# **Grapevine Switching Station Project - ERCOT Independent Review**

ERCOT Transmission Planning

Regional Planning Group

July, 2018

# Grapevine Switching Station

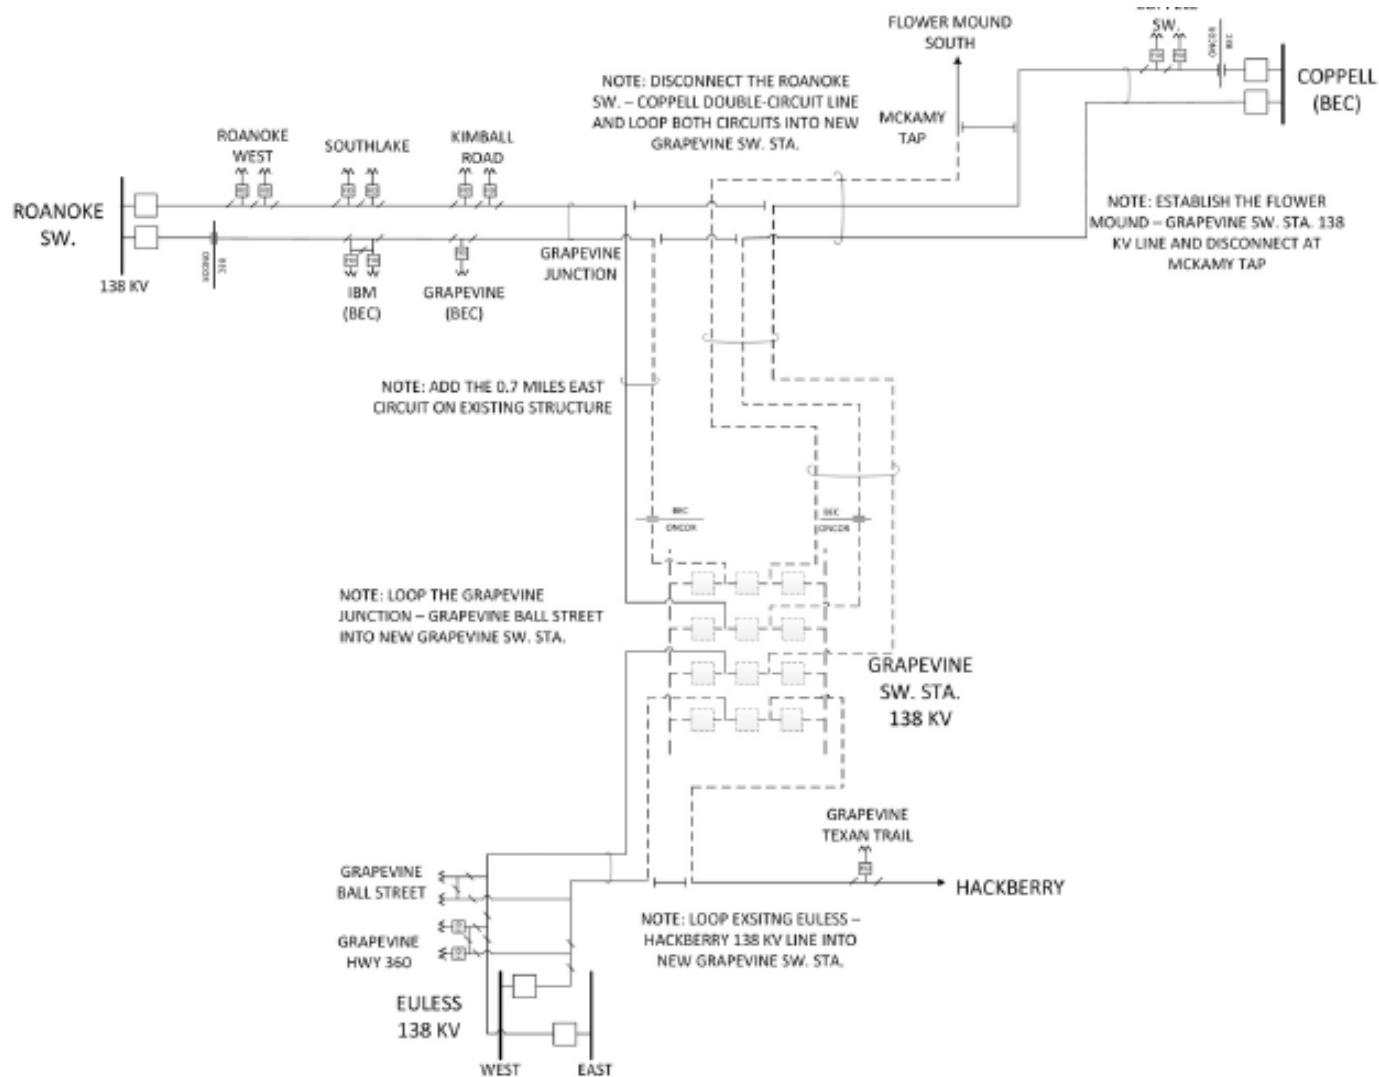
- 12 breakers at Grapevine Sw Sta in breaker and a half layout
- Two Roanoke – Grapevine Sw Sta 138 kV lines
- Two Eules – Grapevine Sw Sta 138 kV lines
- McKamy to Grapevine Sw Sta and two Coppell – Grapevine Sw Sta 138 kV lines – Triple circuit structure
- Hackberry to Grapevine Sw Sta 138 kV line

- ERCOT recommends Option 1 to resolve reliability issues
